MOHAWK COUNCIL OF AKWESASNE
KAWEHNOKE DISTRICT

25-7940 PEACE TREE MALL
NEW FAÇADE PROJECT

ADDENDUM NO. 2

DESIGN ELEVATIONS - OPTION 2

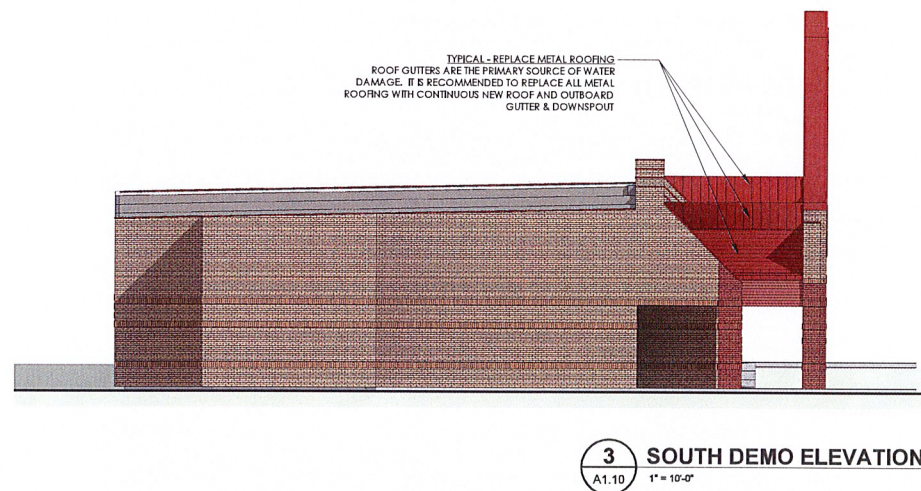
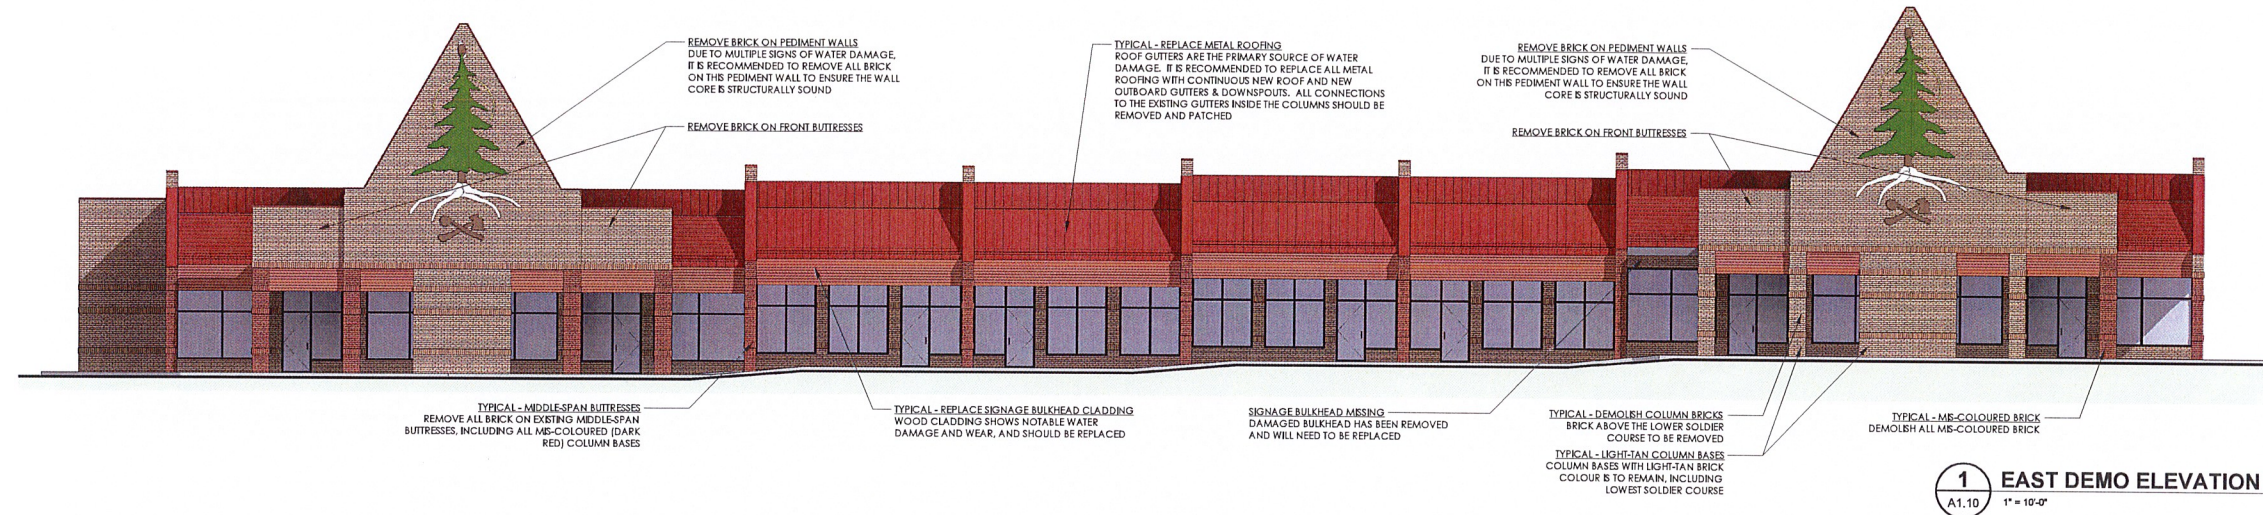
1. RFQ closing date has been extended by a week, to close on July 7th, 2026, at 2:00pm. The deadline for questions is also extended to July 2nd, 2026, at 4:00pm.
2. Please find the architect's renderings for this project. Note that the scope of work is outlined in the structural drawings and in the tender documents. Notation on the renderings are outdated.
